MFN 06-216
Supplement 2

Subject: **Response to Portion of NRC Request for Additional Information
Letter No. 34 –Auxiliary Systems– RAI Numbers 9.3-16 S01, 9.3-17
S01, 9.3-18 S01, and 9.3-19 S01**

**Response to Portion of NRC Request for
Additional Information Letter No. 34
Related to ESBWR Design Certification Application**

**RAI Number 9.3-16 S01, 9.3-17 S01,
9.3-18 S01, and 9.3-19 S01**

Figure 2.2.4-1. Standby Liquid Control System

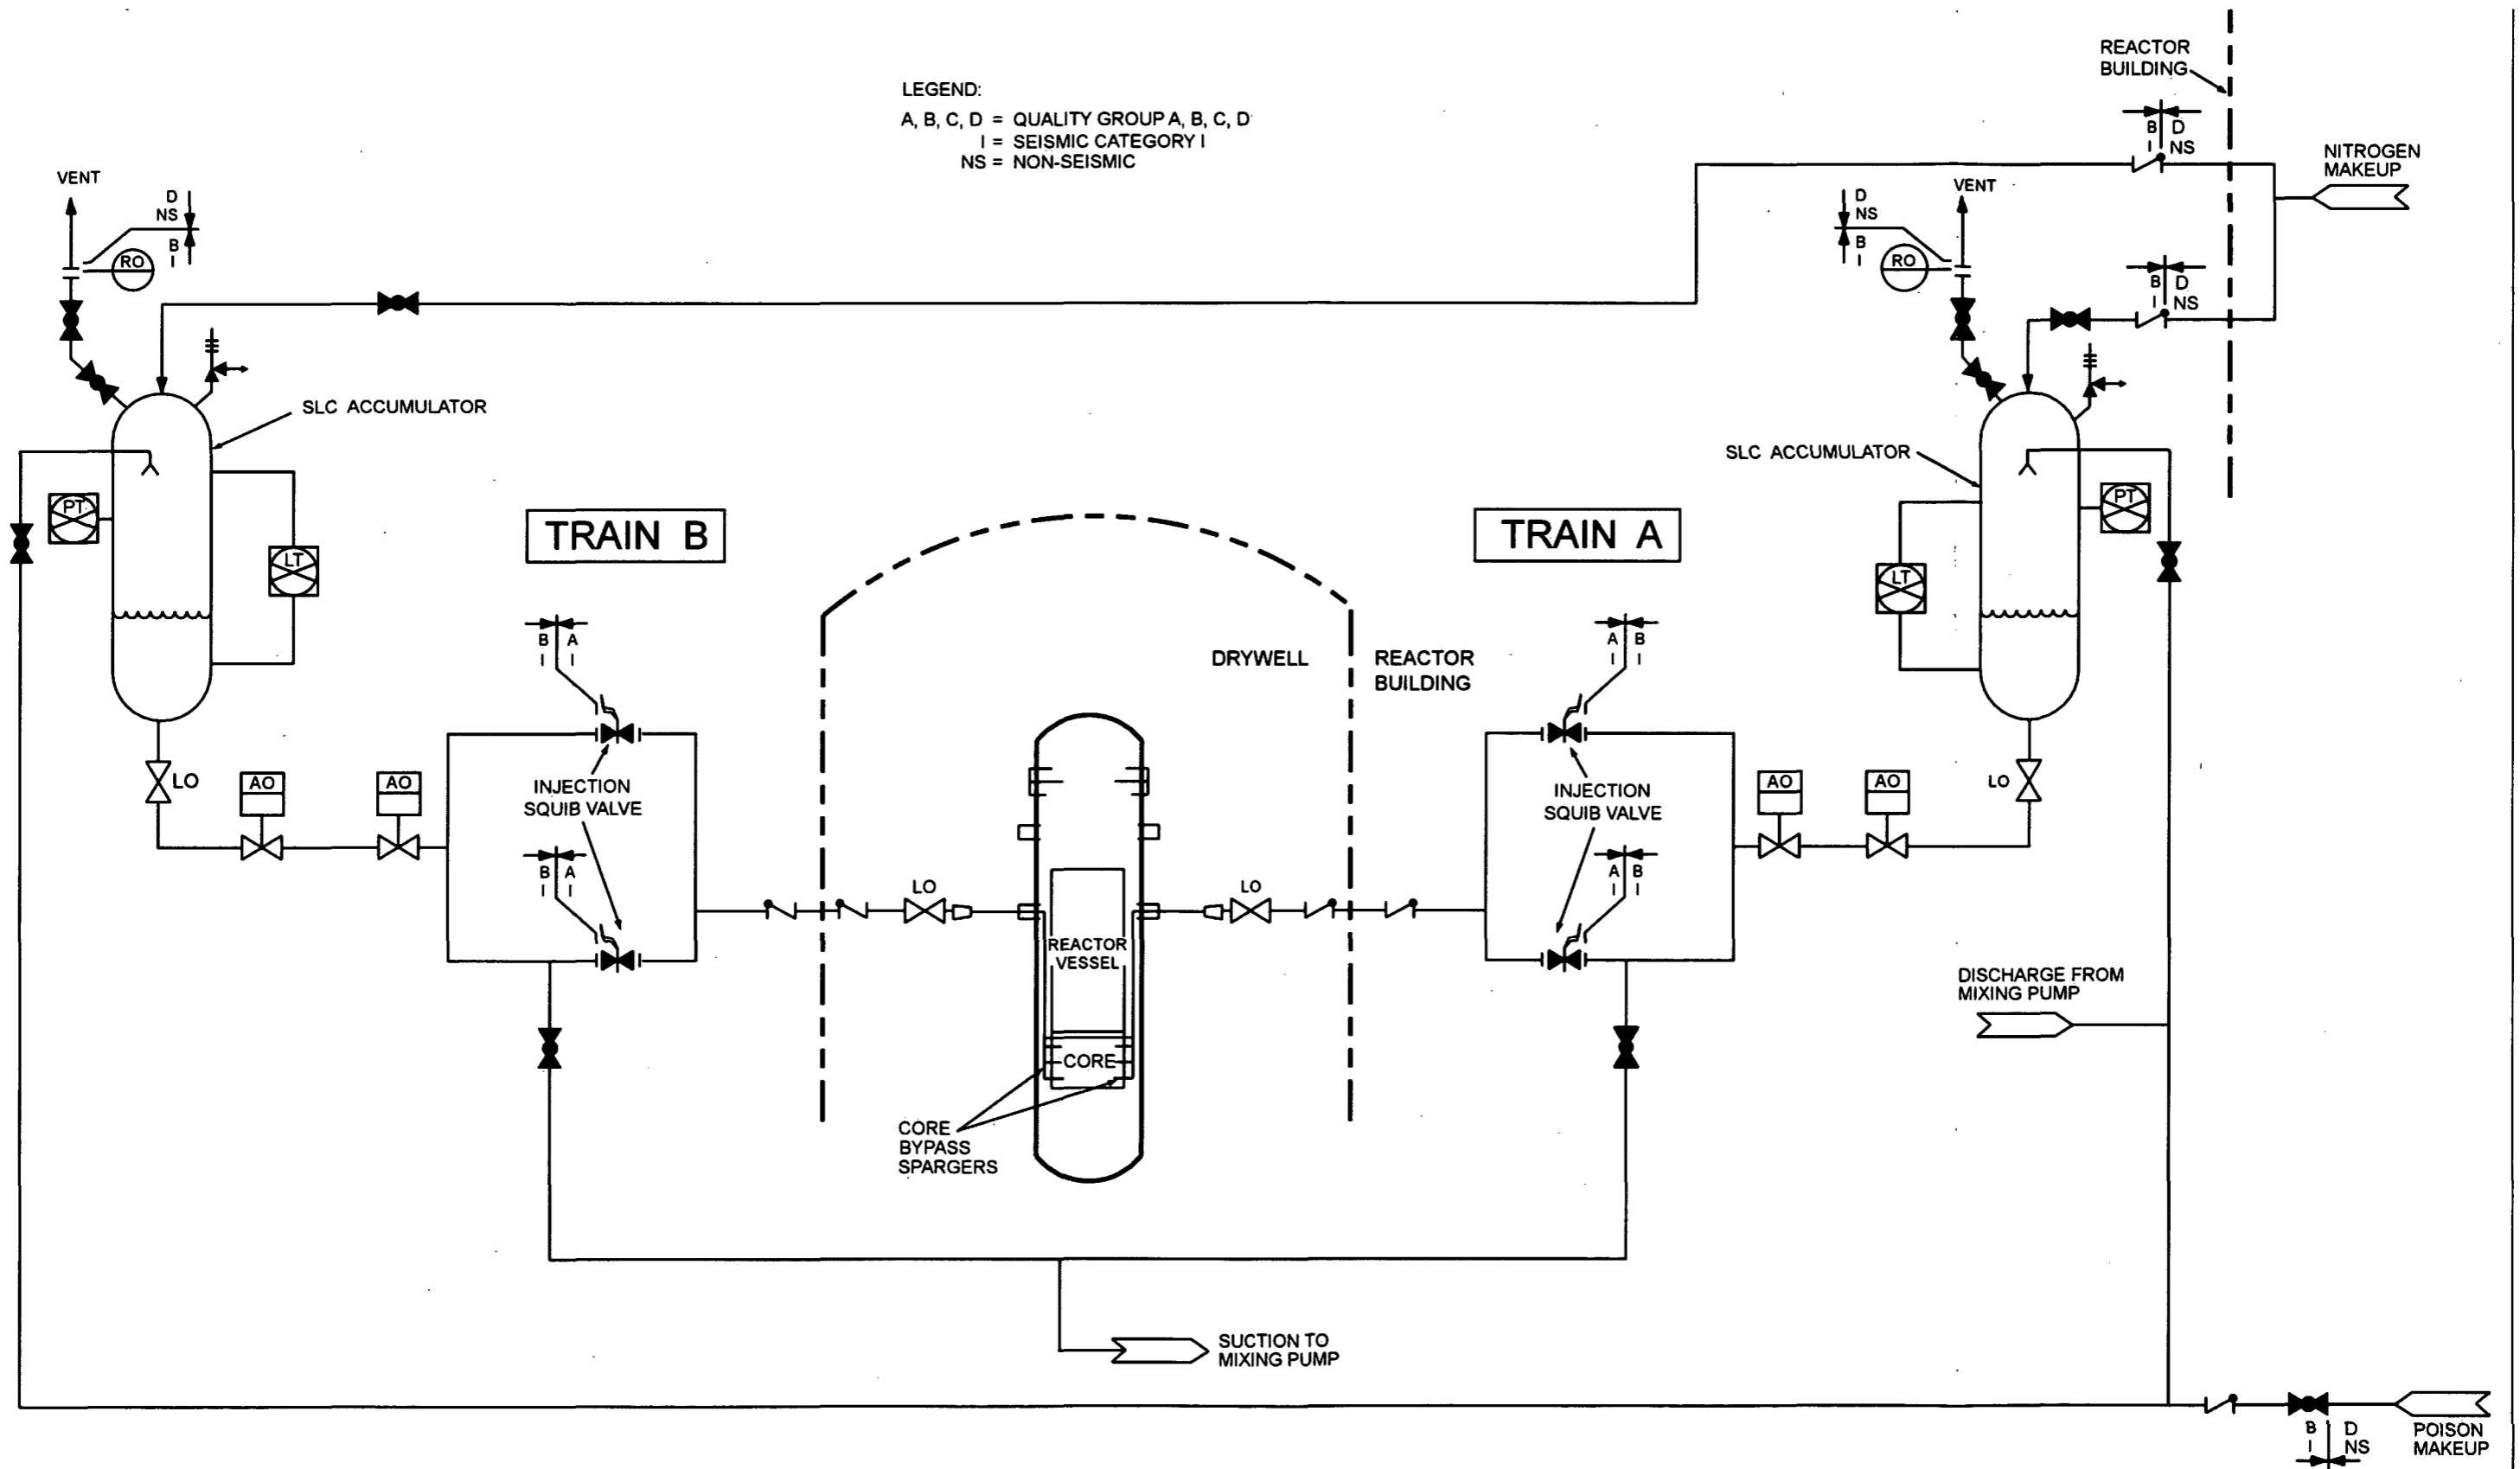
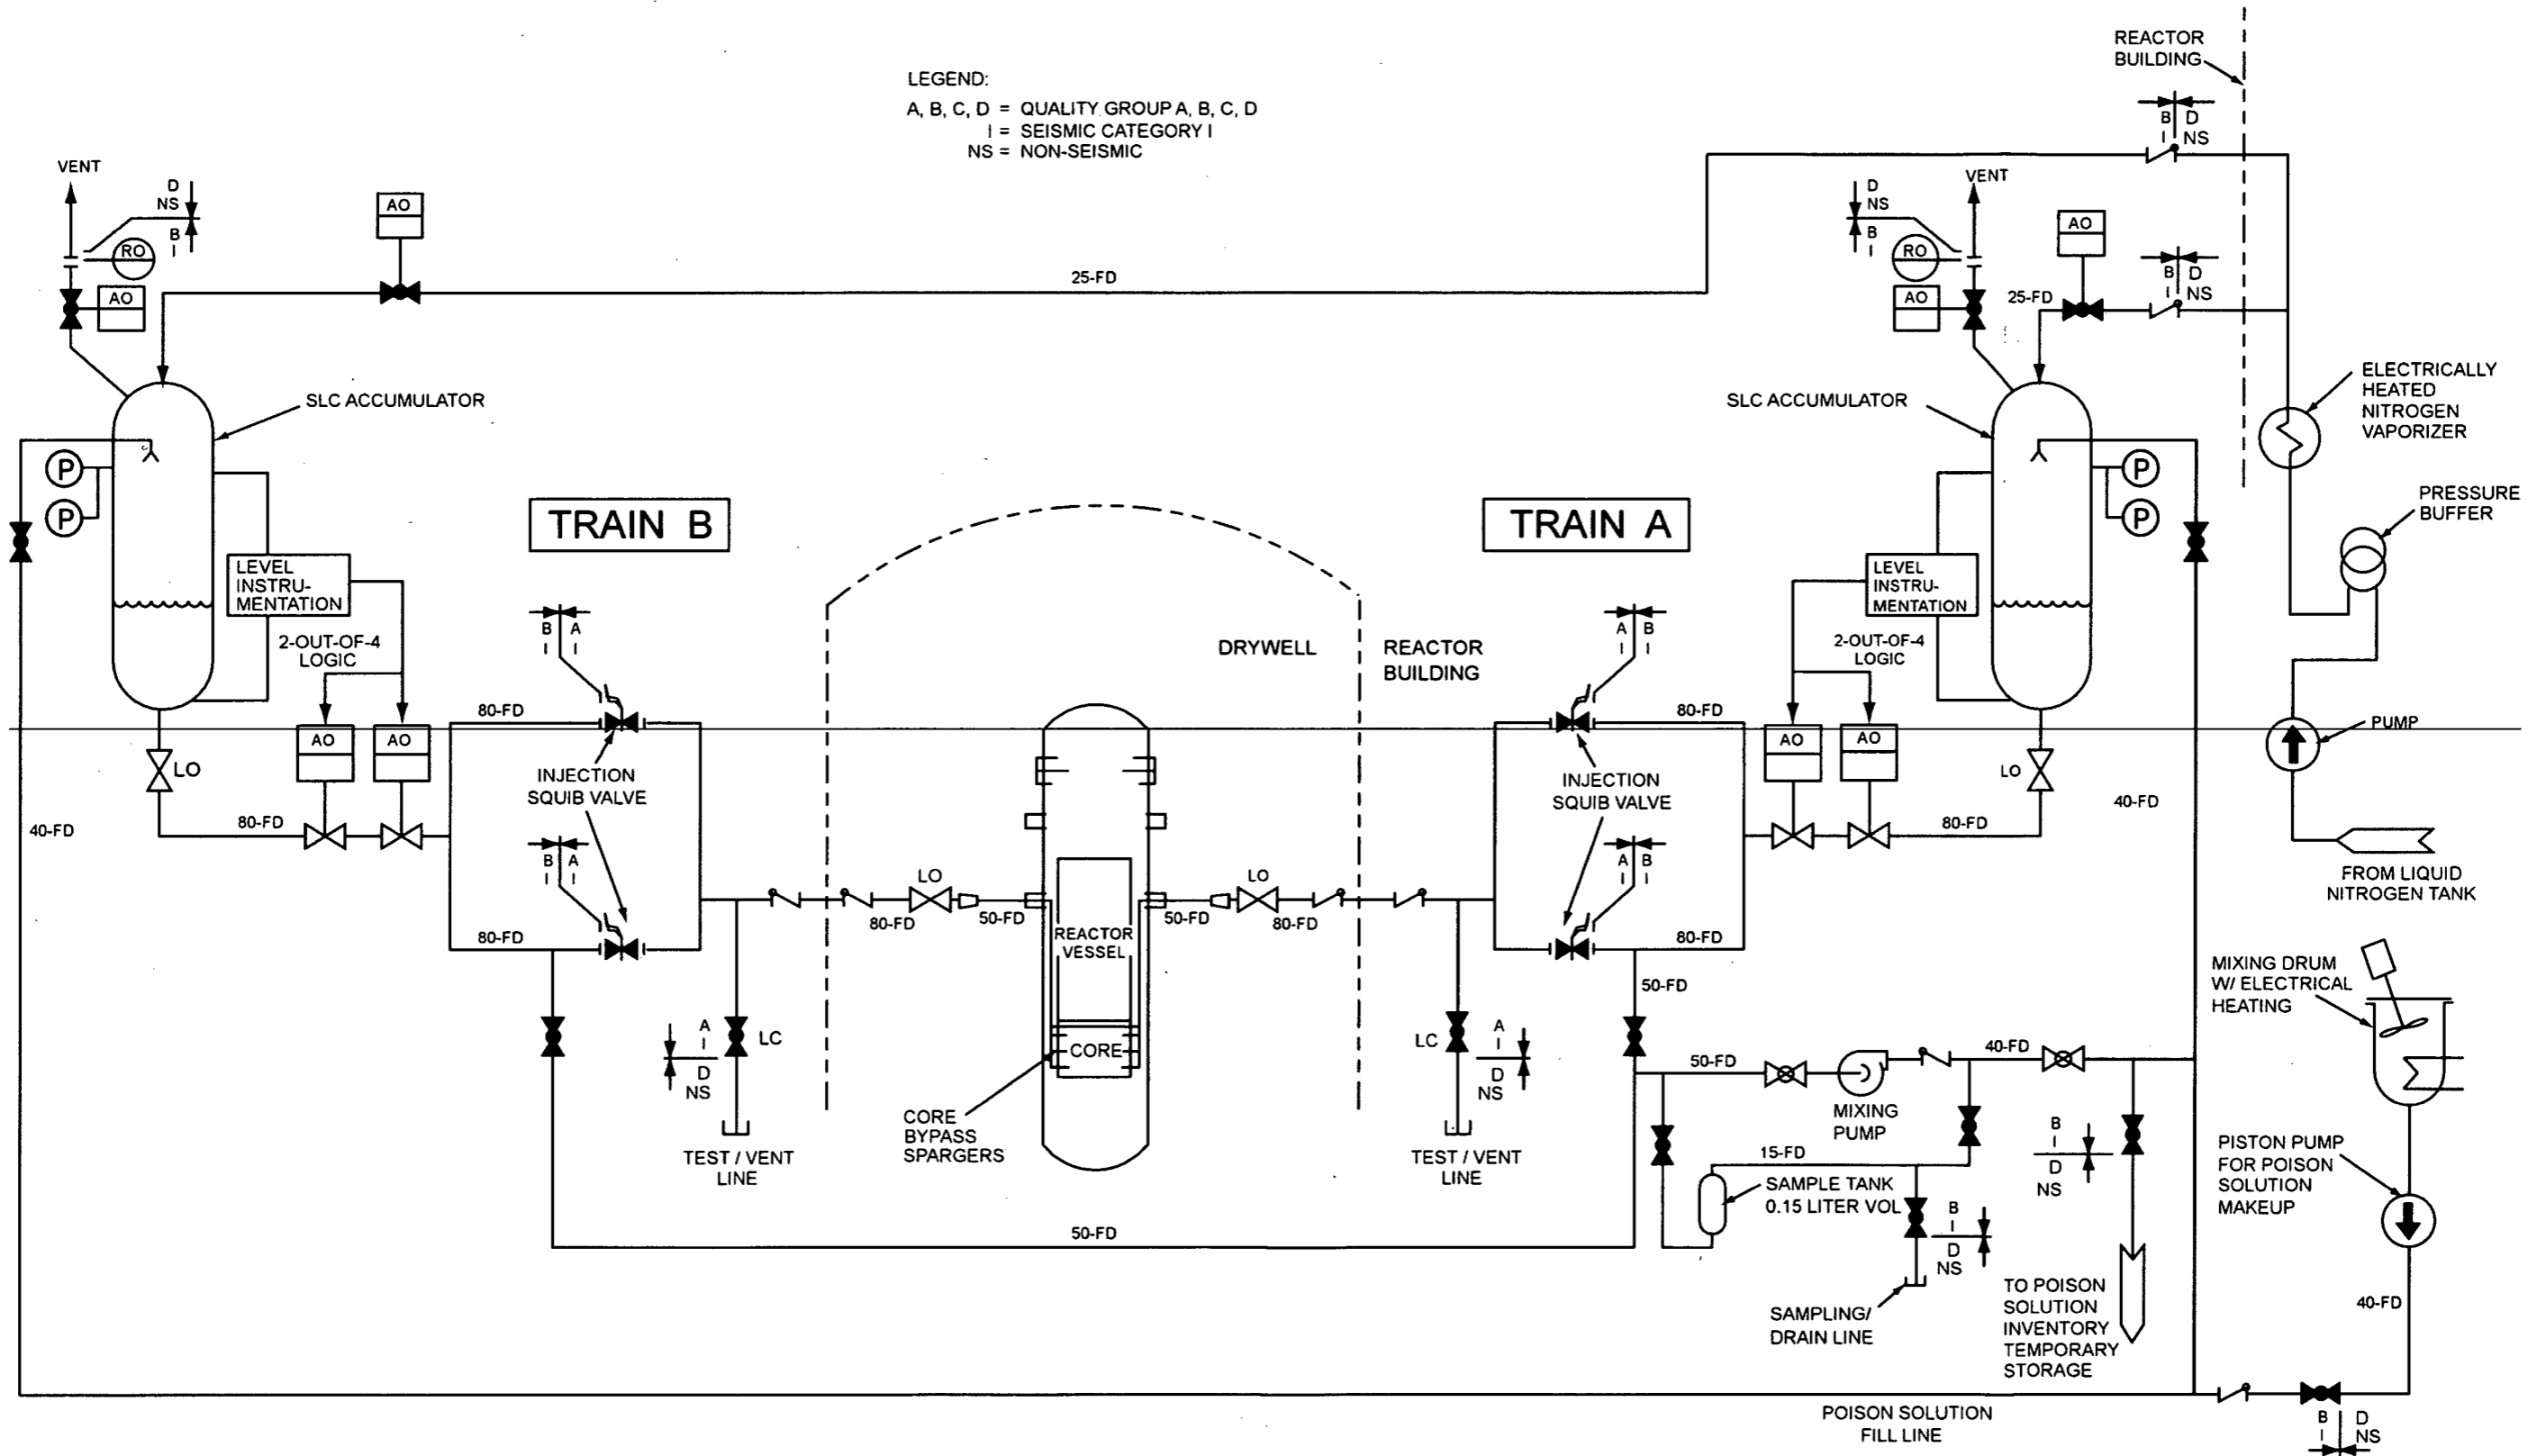
DCD Tier 1, ITAAC Figure 2.2.4-1

Add accumulator relief valve FO30 in addition to the vent shown for the Accumulator. Also, add the set pressure of the relief valve to the ITAAC.

Add accumulator pressure indicator in addition to the level indicator, as pressure is a critical parameter. 2500 psia is indicated in the figure. Clarify whether the 2500 psia is the normal pressure in the accumulator, the design pressure of the accumulator, or the accumulator pressure assumed in the safety analyses. Also, clarify whether the 24.5 cubic meters indicated is the design capacity of the accumulator, or the accumulator capacity assumed in the safety analyses. If these parameters are to be verified by the ITAAC, these values should be included in the ITACC Table 2.2.4-2.

Note: The ITAAC values to be verified should be the values assumed in the safety analyses.

NRC RAI 9.3-19 S01:

Please provide a supplemental response to address this specific RAI rather than referring indirectly to the response to RAI 14.3-1.

The accumulator relief valve is to be added to Figure 2.2.4-1 for DCD Tier 1 Revision 4. The accumulator relief valve setpoint is to be developed during the detailed design phase of the project in accordance with ASME requirements. This setpoint is not within the scope of Tier 2, which is the source of Tier 1. Therefore, the setpoint is not provided in Tier 1.

Accumulator pressure instrumentation was added to Figure 2.2.4-1 for DCD Tier 1 Revision 3, and was shown as dual redundant. However, GEH has reevaluated the level of detail used in DCD Tier 1. While the pressure instrumentation is designed as dual redundant, GEH has chosen to show the pressure instrumentation generically in Figure 2.2.4-1 for DCD Tier 1 Revision 4. See the revised response (Revision 1) to RAI 14.3-83 S01 for further details on level of detail in DCD Tier 1, Figure 2.2.4-1 for Revision 4.

The design pressure and volume were removed from Figure 2.2.4-1 for DCD Tier 1 Revision 3. This level of detail is not required for a Tier 1 figure.

DCD Tier 1, Figure 2.2.4-1 is to be revised for Revision 4 as noted in the attached markup.
